RE: RESPONSE TO INFORMATION REQUEST A MATERIAL CHANGE OF USE (DWELLING HOUSE) OVER LAND AT 14 HIBISCUS COURT, ROCKY POINT, MORE FORMALLY DESCRIBED AS LOT 26 ON RP749732

COUNCIL REF: MCUC 2022_4956/I (Doc ID 1105534)

Attachment I:

Amended Proposal Plans

2 Left Elevation
1 : 100

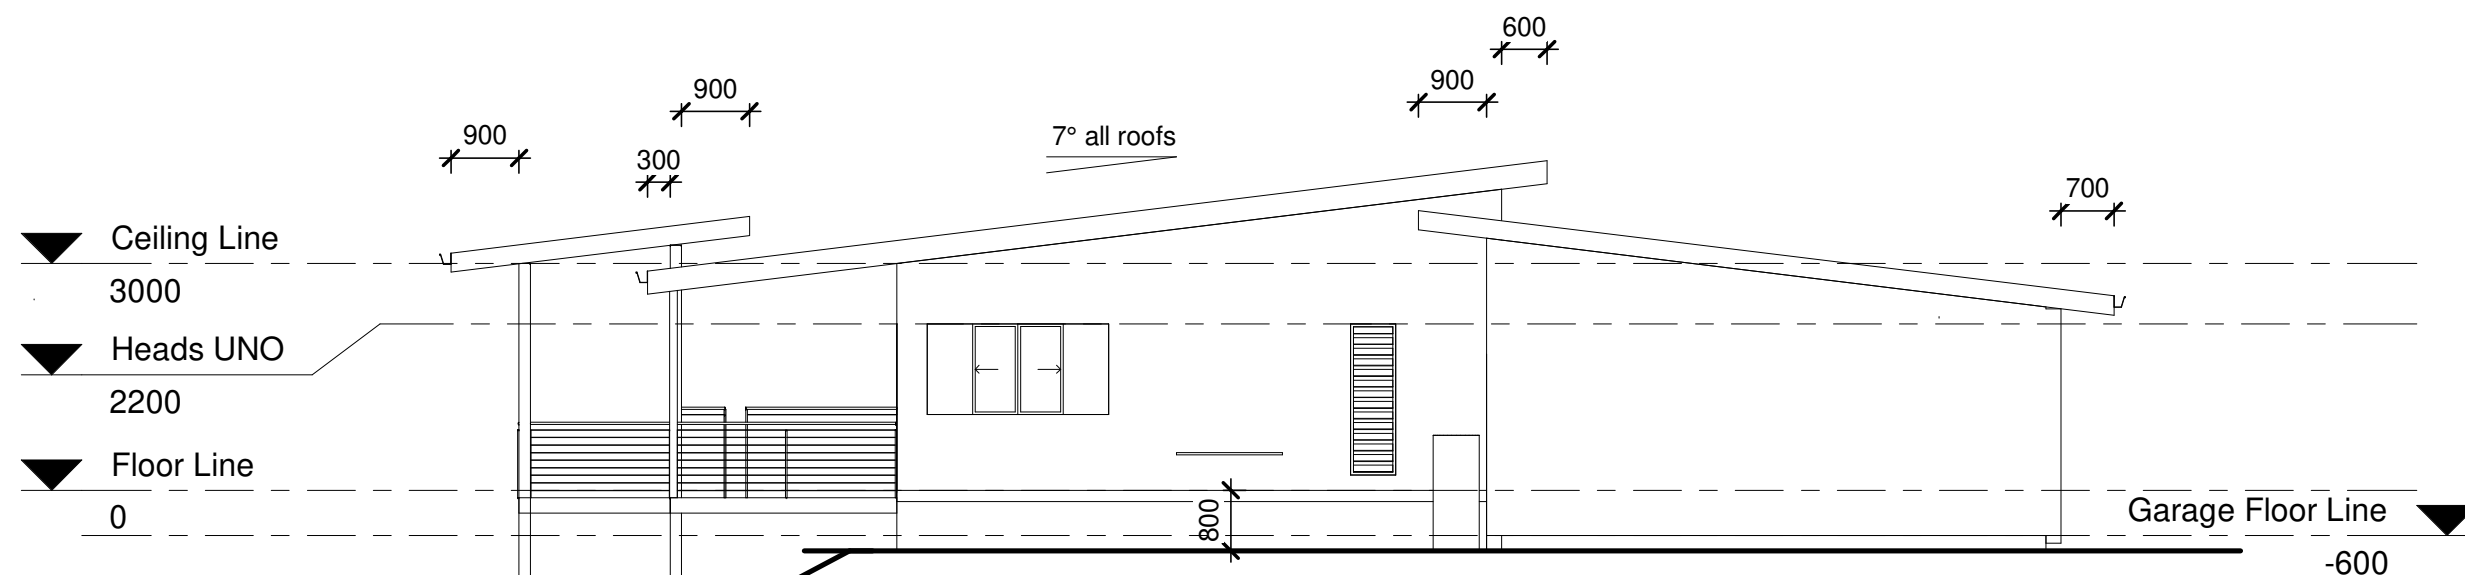
Since the issue of the Information Request on the 30 August 2022, the currency of the Development Application has been maintained through mutual agreement to extend the Information Response Period. As a result of the Information Request and other factors the proposed Dwelling House has been through a number of design iterations. The main notable change is a reduction in the size of the proposed cantilever deck. This now generally aligns with the existing top of bank. The revised plans are included under Attachment I.

It is understood that the requirement for a Visual Assessment was likely driven by the proposed cantilevered building elements and with the amended design the building is now largely limited to the existing top of bank. It is proposed to pull back the existing top of bank by 2m in accordance with the GEO Design Report which will result in slight protrusion over the new top of bank.

It is acknowledged that the site and proposed development is assigned a medium risk under the GEO Design Geotechnical Investigation. However, under s4.7.1 states that following re-profiling, and the adoption of the drainage and erosion protection measures, that it is considered the batter would have a Low Risk in accordance with the AGS 2007 guidelines. The proposed extent of re-profiling is illustrated on the Revised Proposal Plans included under Attachment 1, i.e. 2m pullback of top of bank.

The proposed retaining wall along the western boundary has been removed from the current design. No changes are proposed to the ground levels in this area.

Photograph 1: East of Leilani Drive along the Mossman Daintree Road

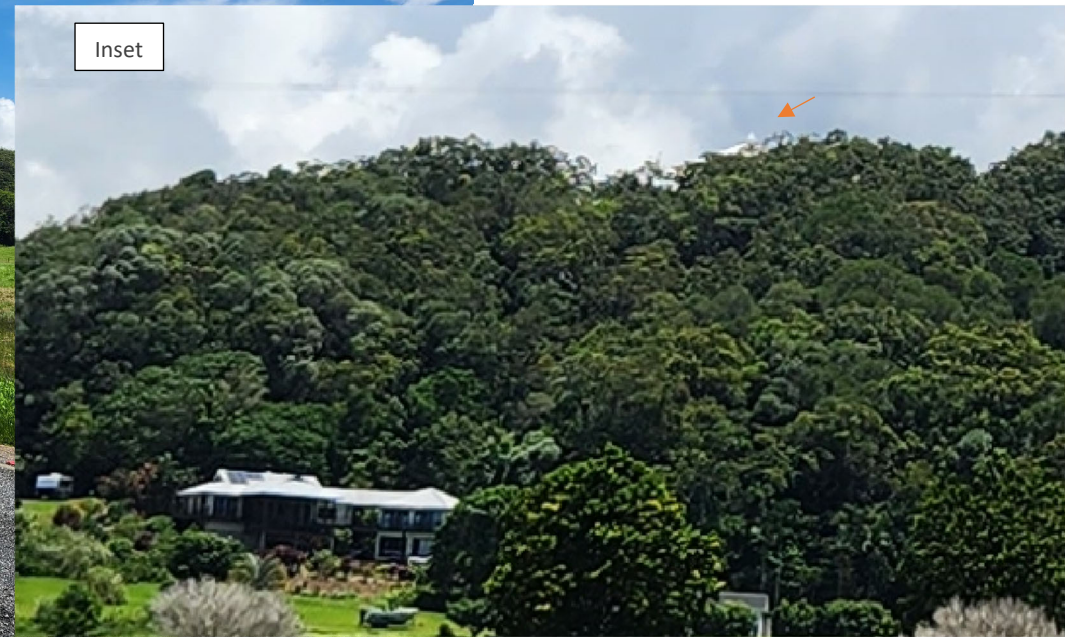
Provide a Visual Impact Assessment in accordance with SC6.6 Planning scheme policy – Landscape values. The visual impact assessment should include a photo montage from vantage points on Captain Cook Highway to the South and West of the site.

The second storey roof is only just visible through the vegetation indicated by the arrow. The proposed development is located to the left of this and is designed with a much lower roof line. The proposed development will be screened by existing vegetation.
